FIELD SERVICE BULLETIN

FSB Number: BJCCFSB2006-75

Subject: V3i Earpiece No_Solder Crack on the Earpiece Pad (Rev A)

Model Affected: V3i Level of Repair: 2

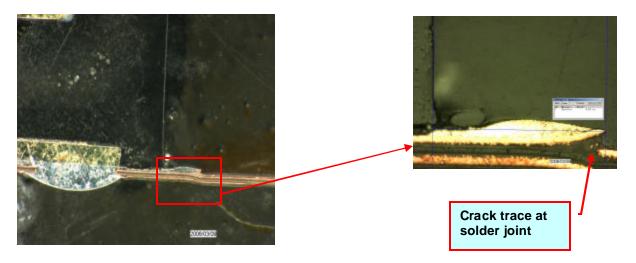
The earpiece performance can recover when pressing the solder pad.

The issue is due to Pflex trace crack at the earpiece solder pad.

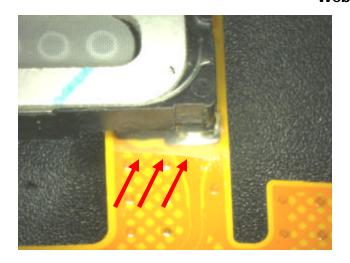
Failure Mode has been confirmed to be speaker pad cracked completely.

The Cross-Section confirmed that the speaker pad has been disconnected at copper level. See the pictures shown below.

Root Cause has been establish as flip assembly induced damage resulting in immediate and latent micro crack of traces leading into the speaker pad-stack.

Long Term Corrective Action:

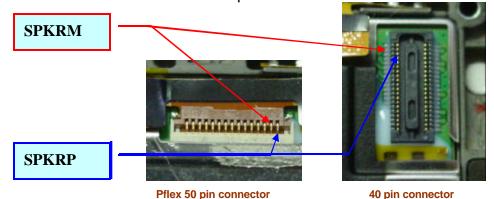
- 1) Foxconn and JinYa have been stopped any re-work during flip assembly process.
- 2) To add UV Curable Epoxy to the earpiece pad area has been approved immediate implementation in the P flex supplier as picture shown below.

The proposed cover coat design change will be applied to make the P Flex more robust to survive from the assembly work.
